7C Defense Against Common-Mode Failure in Safety-Related, Software-Based I&C Systems

The information in this appendix of the reference ABWR DCD, including all subsections and figures, is incorporated by reference with the following departures.

STD DEP T1 3.4-1 (Figure 7C-1)

Figure 7C-1 Implementation of Additional Diversity in SSLC to Mitigate Effects of Common-Mode Failures

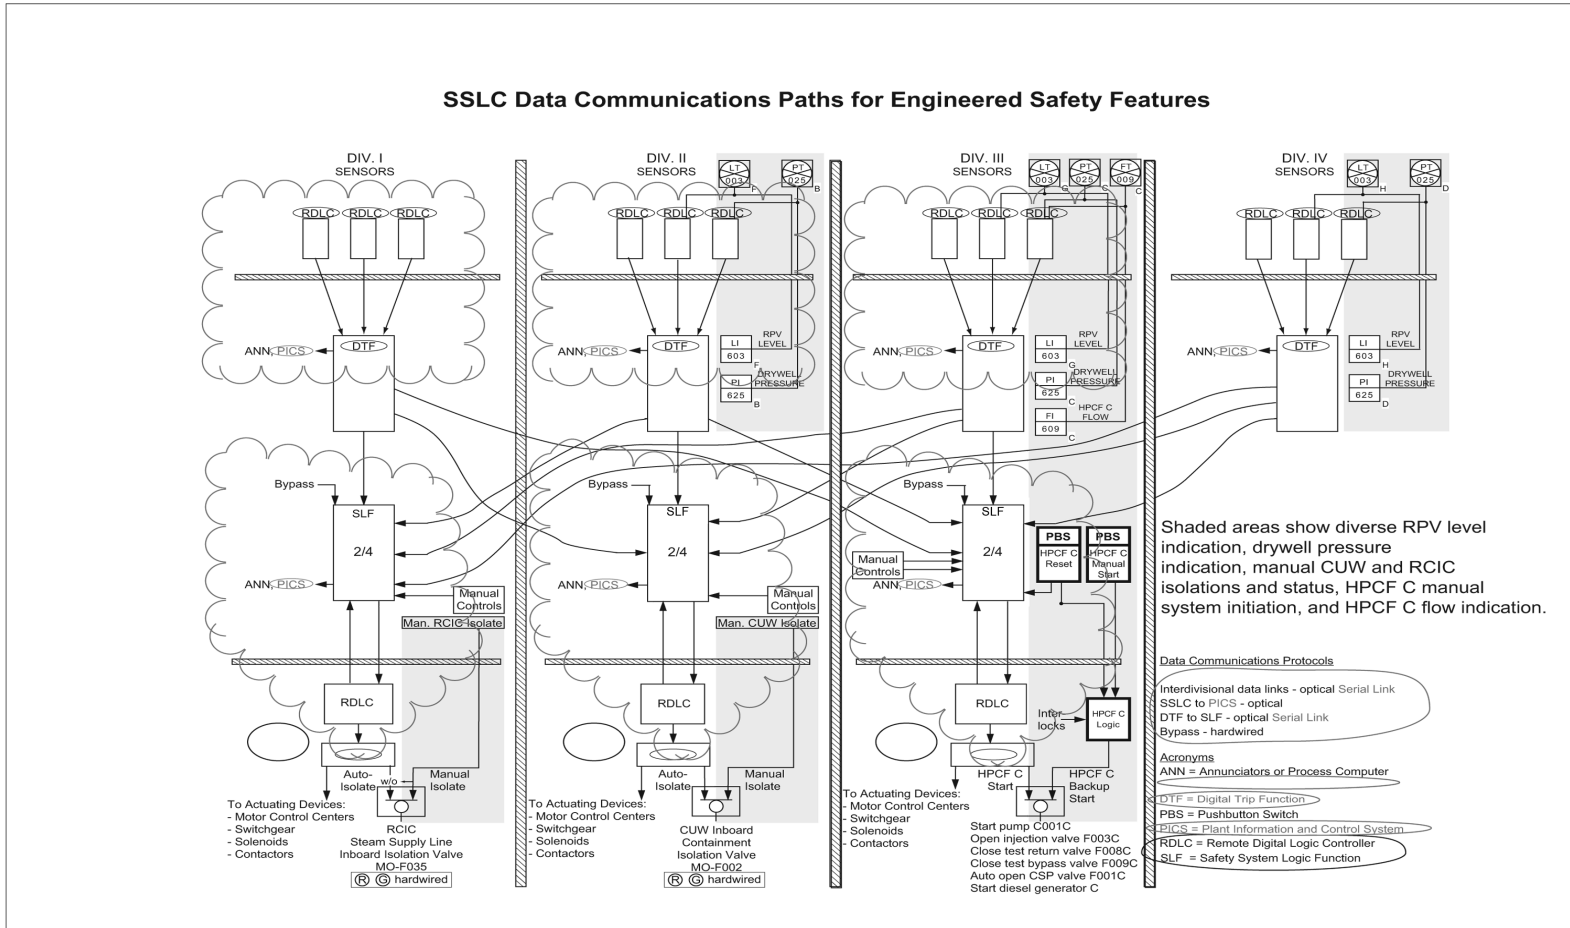
STD DEP T1 3.4-1 (~~Figure 7C-1~~)

STD DEP T1 3.4-1 (~~Figure 7C-1~~)

STD DEP T1 3.4-1 (~~Figure 7C-1~~)

STD DEP T1 3.4-1 ~~(Figure 7C-1)~~
